# CITY OF PORTLAND

# BUILDING PERMIT

Job ID: 2011-08-1844-ALTCOMM

has permission to add Lennox Electric heat on Roof

SHEET TITLE :  
MECHANICAL  
ROOF PLAN

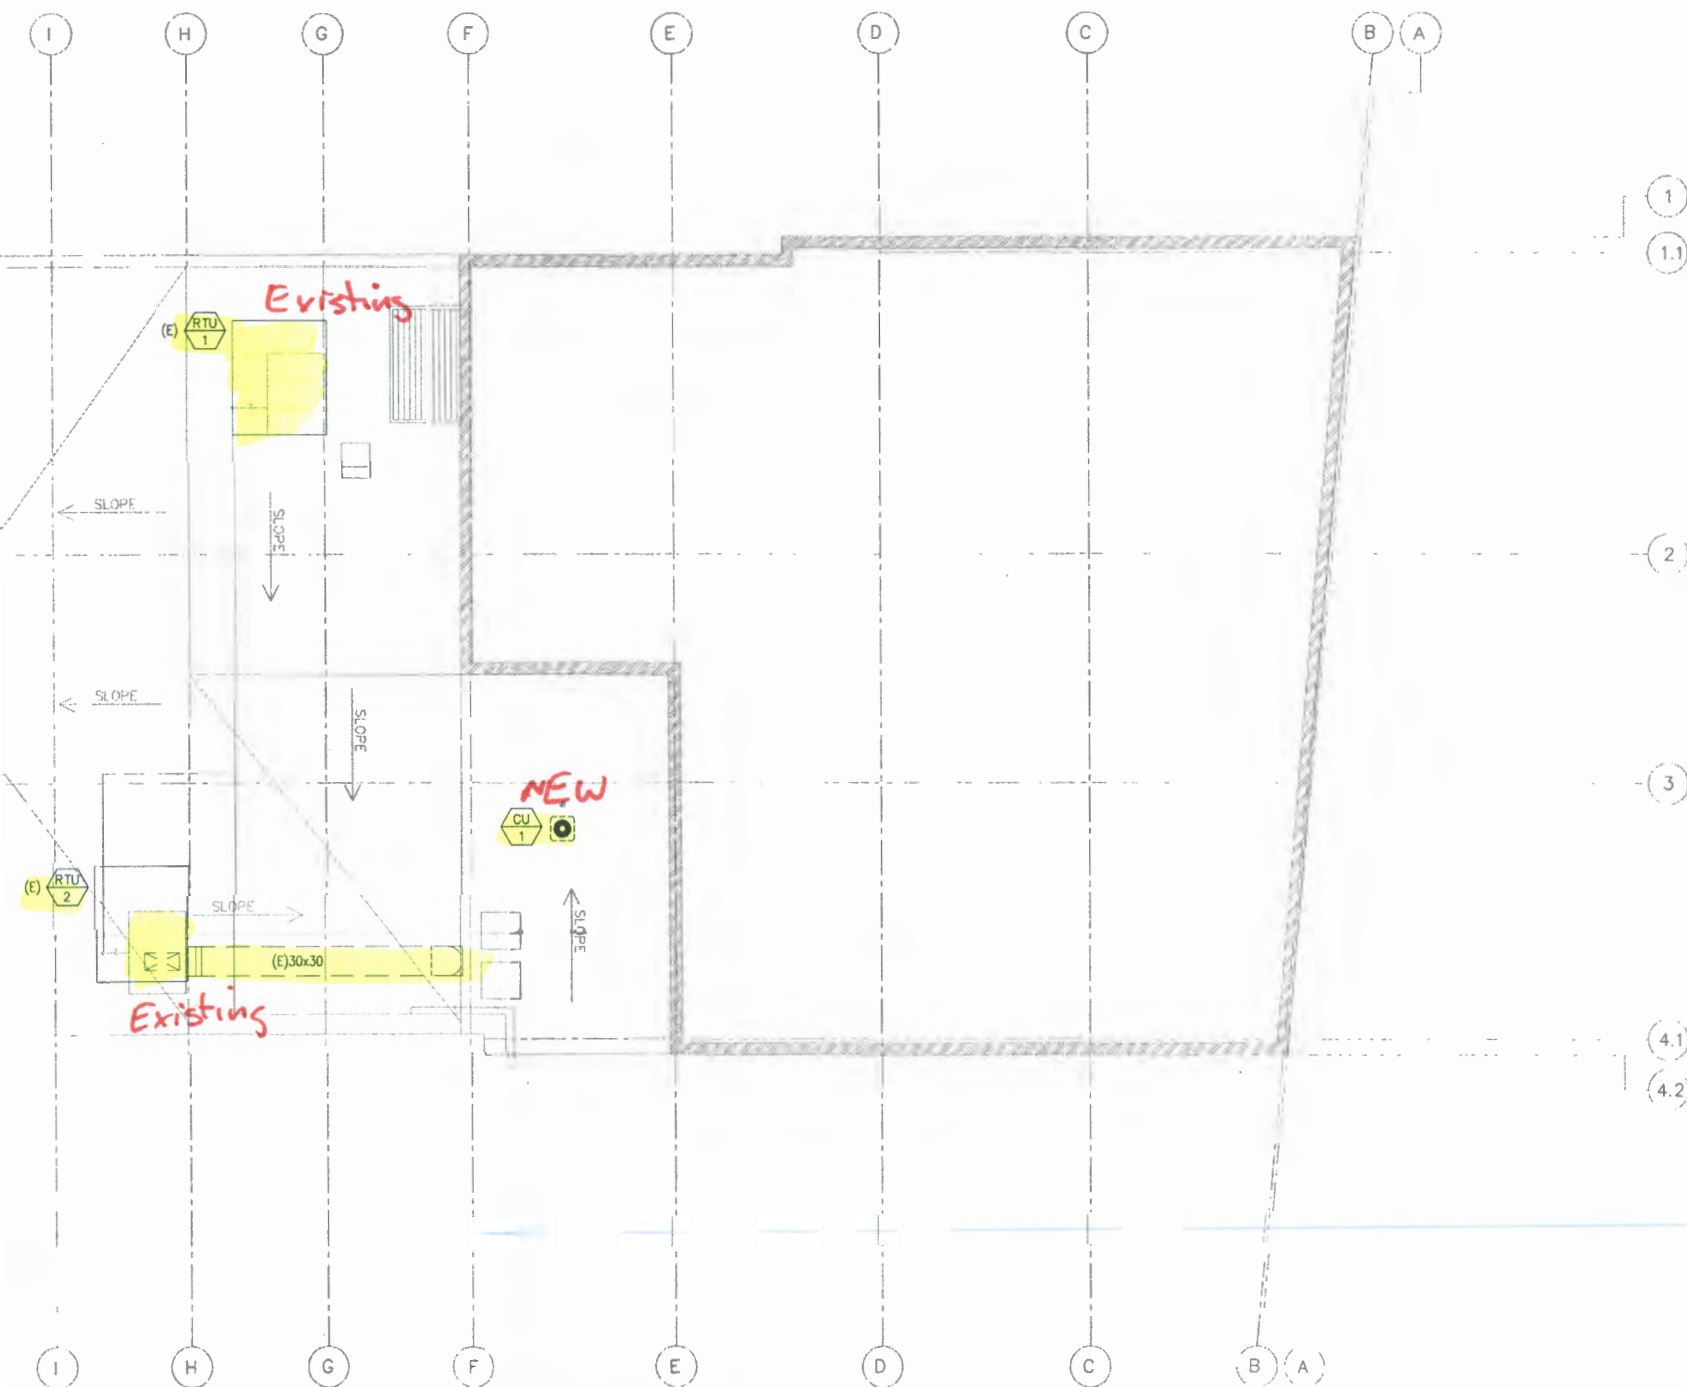
Thank you for the quick response. I am noticing that on page for that you sent me the outdoor sound rating is 76 dBAs. The B-3 Zone allows a maximum of 60 dBAs from 7:00 am to 9:00 pm and a maximum of 55 dBAs from 9:00 pm to 7:00 am. Your unit is well over the maximum allowable.

You will need to first show me how you will mitigate the sound and bring it down to at least the maximum.

Thank you for the additional clarification regarding the noise ordinance listed under Sec. 14-221.1.(b) City of Portland Code of Ordinances. Per our conversation this letter will provide additional information regarding how the sound level emitting from the new rooftop unit RTU-3 attenuates from the rooftop unit to the property line at the rear of the building. The unit is located 25'-10" from the rear property line, which runs along the back wall of the building.

Per the information submitted to you by the mechanical contractor,  $L_1 = 76$  dB (the sound level when standing within 1'-0" of the unit. When calculating the sound level at 25'-10" ( $L_2$ ) the equation above results in the following:

Based on the calculations above, the sound level from RTU-3 would drop to 47.76 dBSPL at roof level on the rear parapet of the building. Please note that this equation measures the sound level from the unit itself (direct sound field) and does not necessarily take into account the sound produced by the other units on the roof, the ambient noise produced by roof top units on or sound reflections caused by adjacent buildings.

Our understanding is that the 47.76 dB is within the City of Portland's requirement of 60 dB during the day and 55 dB during the evening. Please let me know if you require any additional information at this time prior to releasing this project for permit.
